SERVICE BULLETINS

93-2

EXTENDED FINGER TIPS

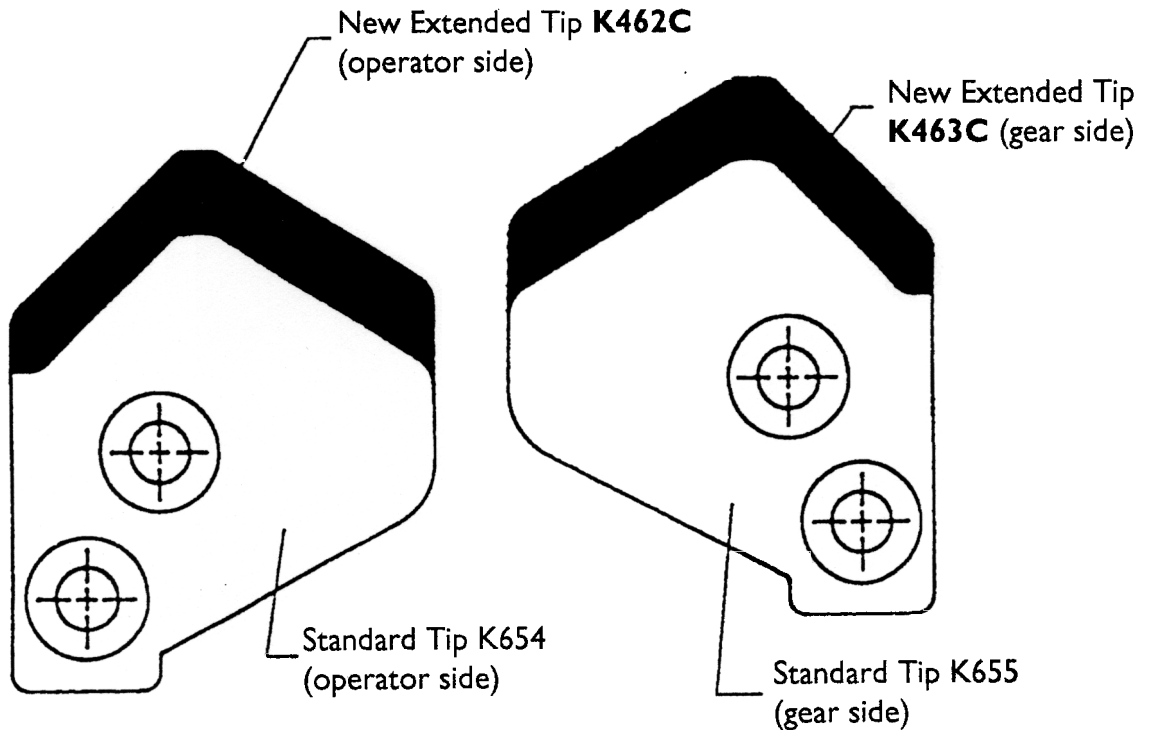
We have extended our drum finger tips to provide for easier set up when making bags within the minimum face range on an H.G. Weber bag machine. It is now possible to gain an additional 1/4 inch adjustment (1/8 inch on each side).

- Shaded area shows the extended area over standard drum finger tips.
- Cast steel construction.
- Can be used as direct replacement for standard tips.
 - **K462C** can replace K654
 - **K463C** can replace K655
- For model #5 and #7 Weber S.O.S. bag machines.
